Well Name: BIG EDDY UNIT DI 30
WEST 15-20

Type of Submission: Notice of Intent

Type of Action: APD Change

BIG EDDY UNIT DI 30 West 15-20 8H
APD ID# 10400097403
SUNDRY LANGUAGE

[Figure E] 4 String – Uncemented Annulus between 2nd Intermediate and Production Casing Strings. (Reference R-111-Q: Exhibit B)

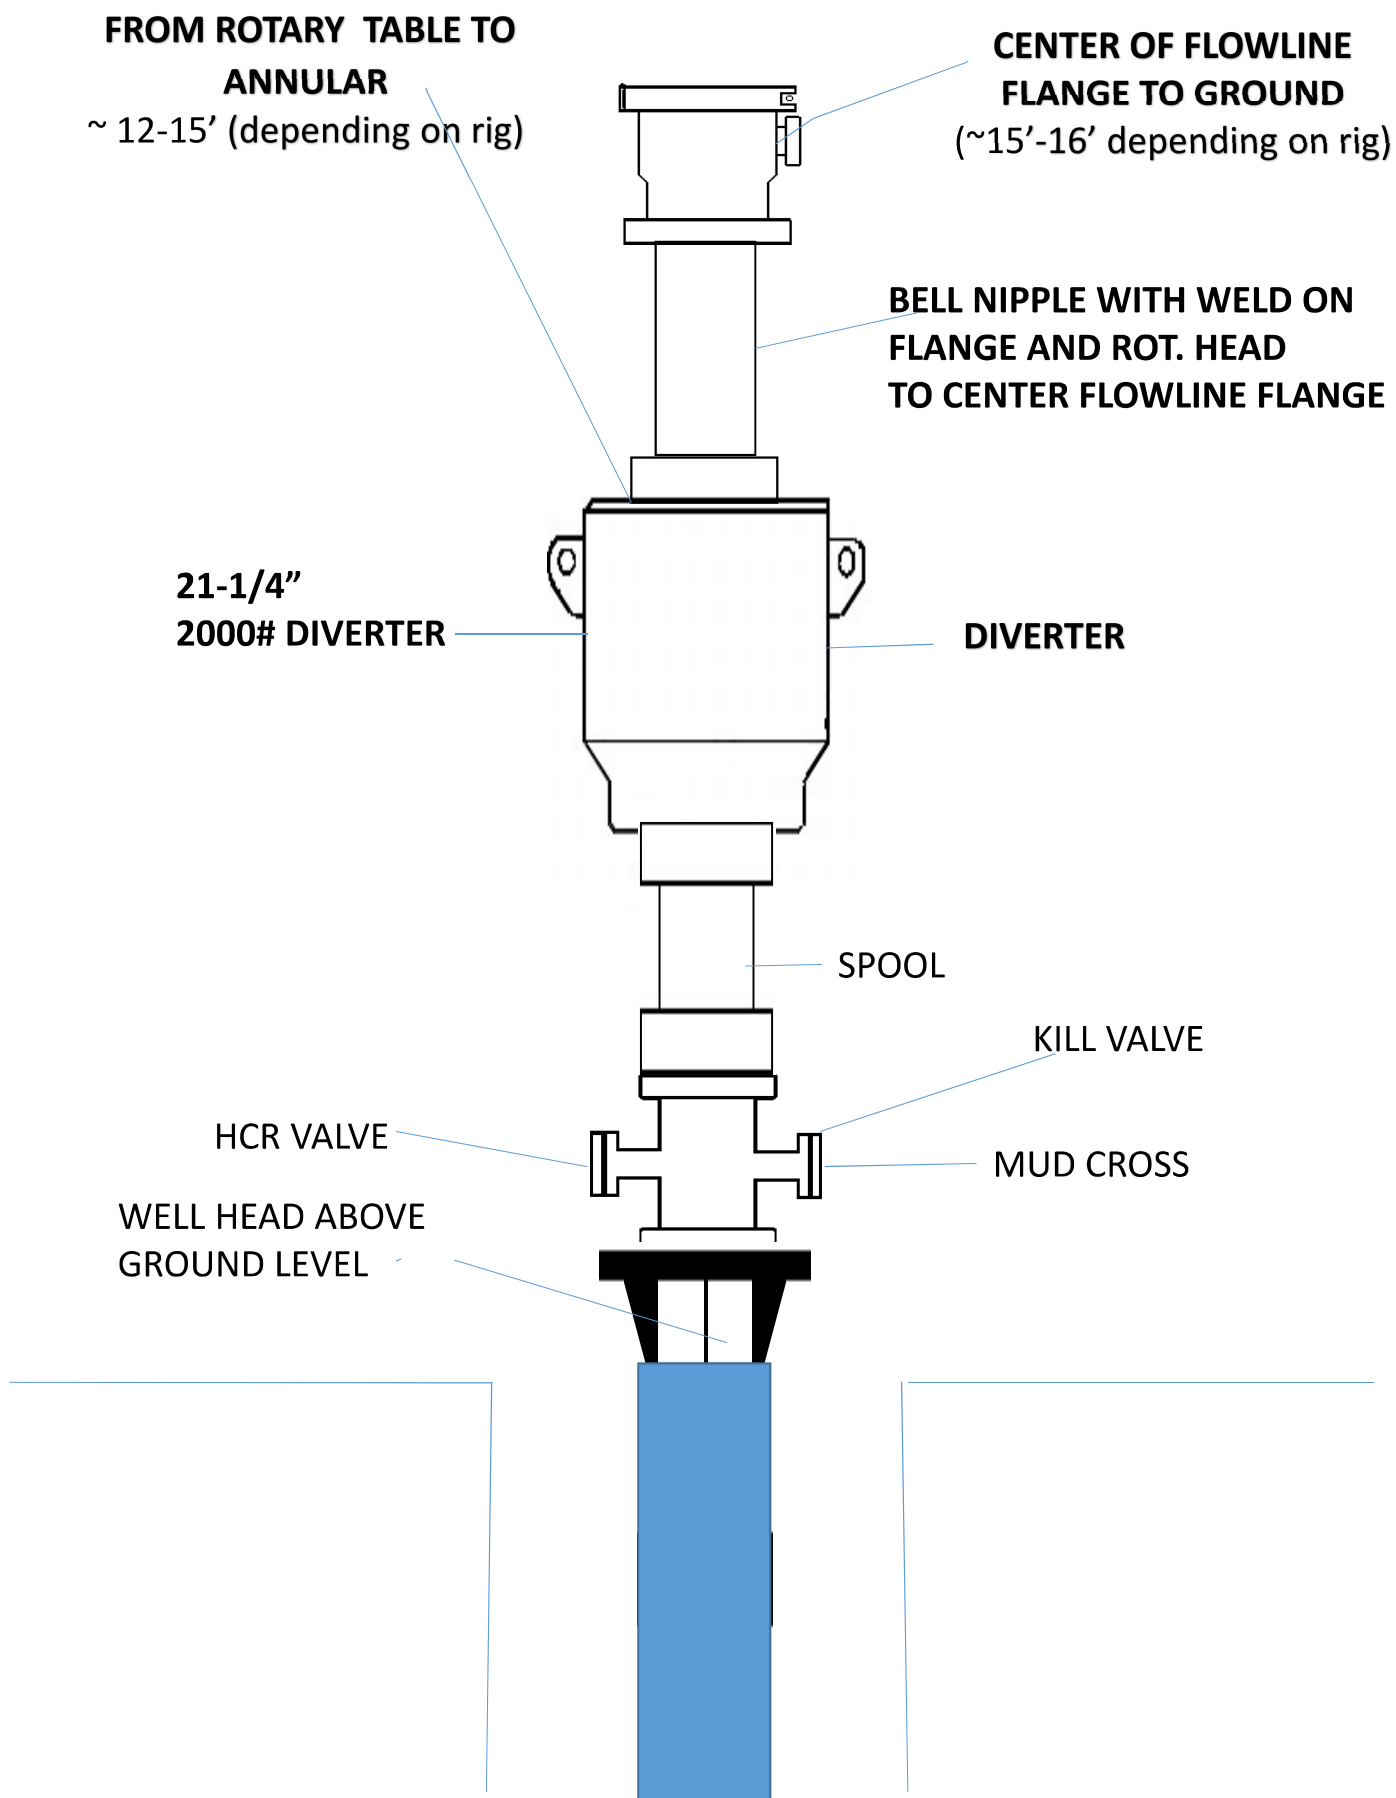
1. Casing design to be changed from the proposed 4-string engineered weak point design to a 4-string design with an uncemented annulus between 2nd intermediate and production casing strings
2. Associated changes required in the cement program & the mud circulation system as per the newly proposed casing design mentioned above

Open 2nd intermediate x production annulus to monitor during completion. In the event of production casing failure, pressure will either release at surface or into the formation below 2nd intermediate shoe in the Delaware Mountain group / Brushy Canyon relief zone (R111Q Figure E)

- Alignment with KPLA requirements per schematic below, with open 2nd Int x production casing design and utilizing new casing that meets API standards.

Changes approved through engineering via **Sundry 2822718** on 12-5-2024 _____. Any previous COAs not addressed within the updated COAs still apply.

APD is within the R-111-Q defined boundary. Operator must follow all procedures and requirements listed within the updated order.

4. The minimum required fill of cement behind the 6 inch production casing is:
 - Cement should tie-back **500 feet** into the previous casing but not higher than **USGS Marker Bed No. 126. Operator must verify top of cement per R-111-Q requirements.** Submit results to the BLM. If cement does not circulate, contact the appropriate BLM office. **Wait on cement (WOC) time for a primary cement job is to include the lead cement slurry due to cave/karst, Capitan Reef, or potash.**
